**Response to Submissions and Request for Information
Digital Advertising Sign - Enmore Road, Newtown (DA/22/7964)**

Attachment A - Response to RFI

Attachment B – Response to submission received from Inner West Council

Attachment C - Response to submission received from City of Sydney Council

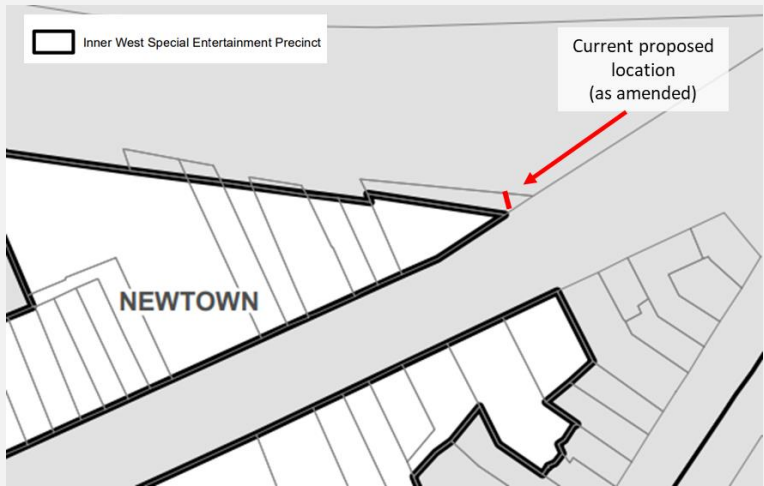
Ref.	Matters raised by Inner West Council	Response
		<p><u>Impact on residential properties</u></p> <p>There are only a relatively small number of residential properties in close proximity to the site, and even fewer with potential views towards the sign.</p> <p><i>Low density residential – Bedford Street</i></p> <p>The proposed sign as amended sign is now approximately 50m west of the residences along Bedford Street. Moreover, it will be orientated towards the Enmore Road/King Street intersection to be visible to traffic travelling west, and not directed towards these residences.</p> <p>There is also built form and vegetation between the site and these properties, including the railway and railway overhead wires/lines as shown in the figure below. This will further restrict any views of the sign from these residences and ensure the sign does not protrude above surrounding environment.</p> <p>The sign will also be programmed to adhere to the strict lighting controls/levels recommended by the lighting consultant in the LIA for the site as outlined in the response at Reference U and Attachment K. These lighting controls/levels will ensure the sign complies with the illumination requirements set out in the Australian Standards and Signage Guidelines. Specifically, the brightness of the LEDs will be controlled to provide upper and lower thresholds and will include a light sensor to automatically adjust the brightness of the display area to the specific lighting conditions i.e time of day and inclement weather.</p> <p>In complying with these standards, the proposed signage will not result in unacceptable glare and impact the visual amenity of nearby residential properties.</p>

Ref.	Matters raised by Inner West Council	Response
		 <p data-bbox="882 868 1635 900">Figure 4: View towards the site from Bedford St (Source: Keylan)</p> <p data-bbox="882 925 1308 957"><i>Shop top housing – 8 Enmore Road</i></p> <p data-bbox="882 989 1890 1046">Views of the proposed sign from shop top housing at 8 Enmore Road are expected as follows:</p> <ul data-bbox="882 1053 1980 1270" style="list-style-type: none"> • views of the sign only possible from the enclosed balconies (private open space is located to the rear of each apartment) • only oblique views of the signage structure (partial side and rear) from the balconies (indicative photomontage from street level shown below) • views framed by existing mature vegetation located behind the structure – the sign will not be viewed from balconies as a protruding structure and therefore no adverse impacts on broader district views are expected
